SERVICE BULLETIN

Inspection and/or replacement of the valve push-rod assy., rocker arm left and rocker arm right for ROTAX® Engine Type 912 i, 912 and 914 (Series)

ATA System: 72-30-00 Cylinder head

MANDATORY

Fig. 1
Visual inspection

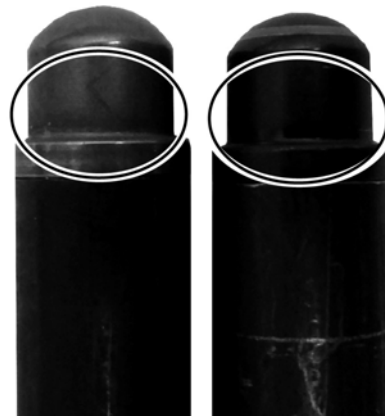
Perform visual inspection of all push-rod ball sockets on all cylinder.
 Check for color. See Fig. 1.

| Color | Evaluation |
| Silver surface | Valve push-rod is OK. No further action required for this valve push-rod. |
| Black surface | Valve push-rod is NOT OK. See section. 3.1.3) Replacement of affected parts. |

Fig. 2

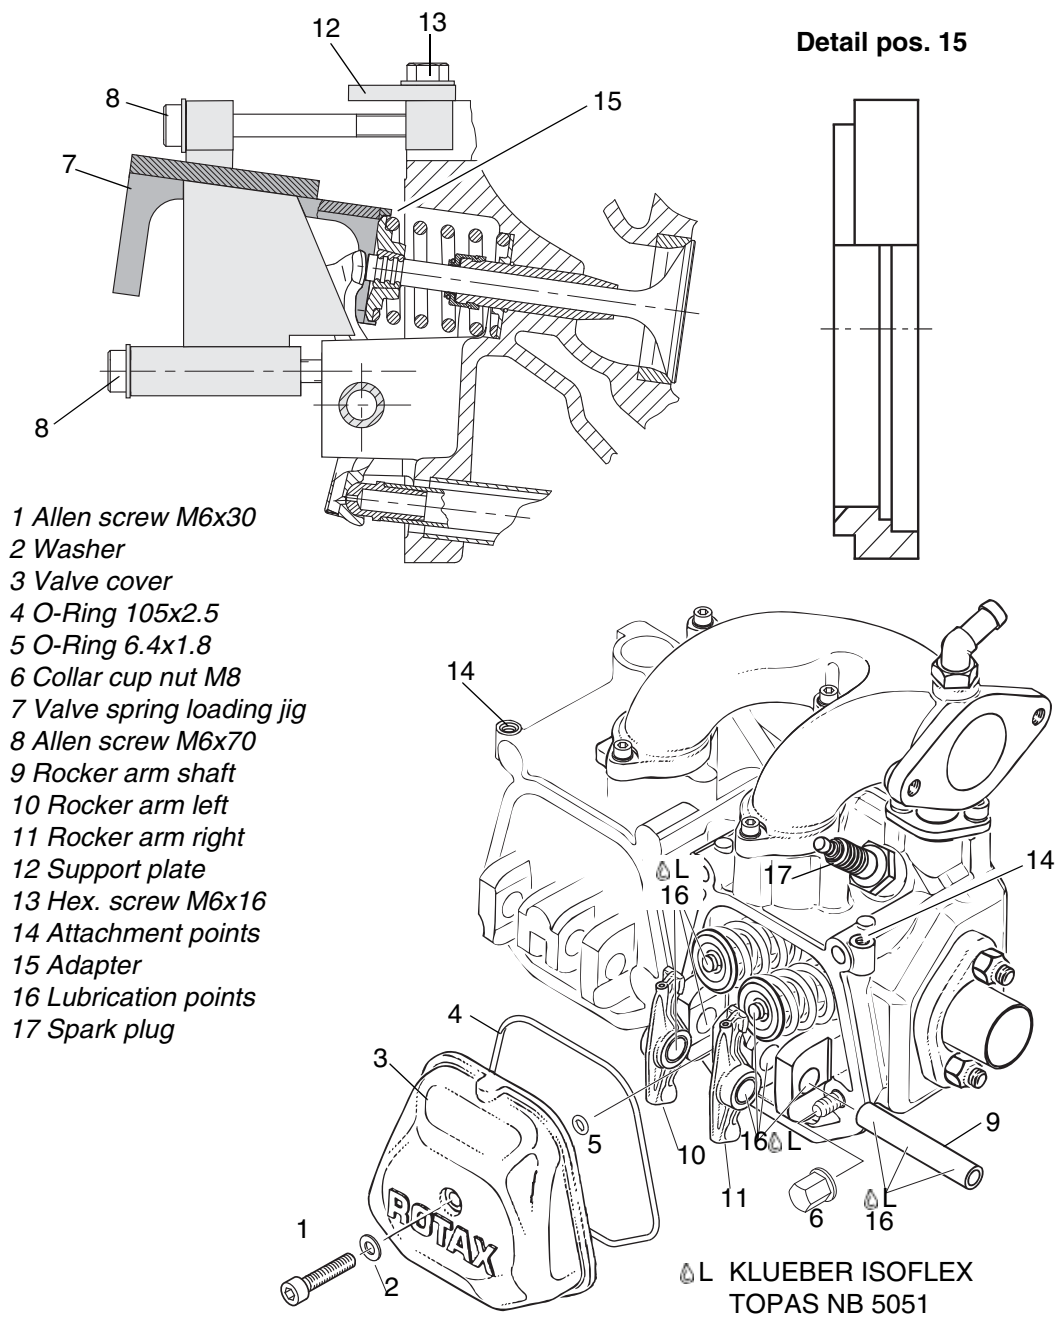
| Step | Procedure |
|------|---|
| 1 | Loosen Allen screw (1) M6x30 with washer (2) from valve cover (3), and remove it together with large and small O-rings (4) and (5). |

| Step | Procedure |
|------|--|
| 3 | Attach the support plate (12) to the valve spring loading jig part no. 877387 (7) with 2 hex. screws (13) M6x16 at the attachment points (14) on the cylinder heads. |
| 4 | Put adapters (15) on the valve spring loading jig. |
| 5 | Attach the valve spring loading jig on cylinder head and support plate with 2 Allen screws (8) M6x70 and depress both valves with 3 turns. |

| Step | Procedure |
|------|---|
| 6 | This will relieve the pressure from both hydraulic tappets. Now the rocker arm shaft (9) may be easily pulled out. Lift out both rocker arms (10) and (11). |

| Step | Procedure |
|------|---|
| 2 | Insert new O-ring (4) 105x2.5 and O-ring (5) 6.4x1.8 into the valve cover (3). |

| Step | Procedure |
|------|--|
| 4 | Tighten the new Allen screw (1) M6x30 with washer (2) to 10 Nm (89 in.lb). |

Fig. 3

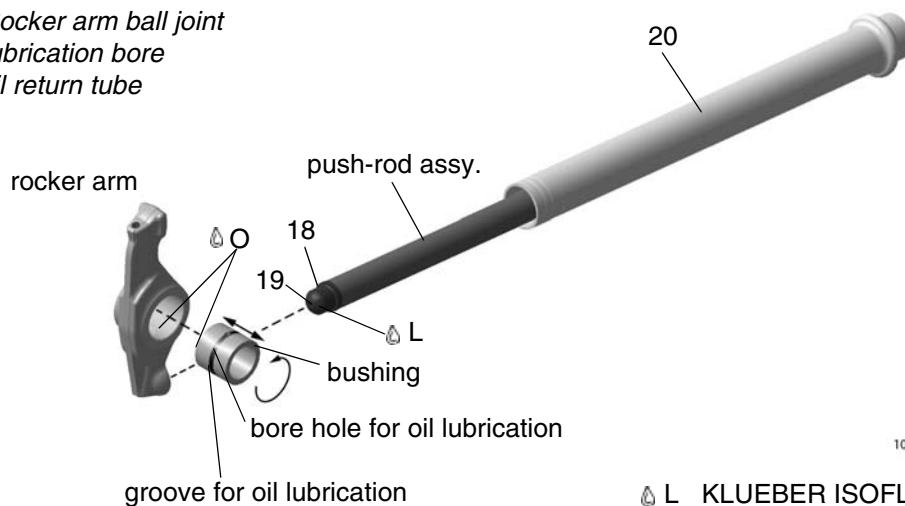
| Step | Procedure |
|------|---|
| 7 | Replace only affected parts as per section 2.3 . See also Fig. 3 . |
| 8 | Apply KLÜBER ISOFLEX TOPAS NB 5051 (16) on both push-rod ball sockets and contact areas of rocker arm and slide push-rod into the oil return tube (20). |
| 11 | Place rocker arm left (10) and rocker arm right (11) in cylinder head, apply KLÜBER ISOFLEX TOPAS NB 5051 (16) on rocker arm shaft (9) and insert it into its bearing support. |
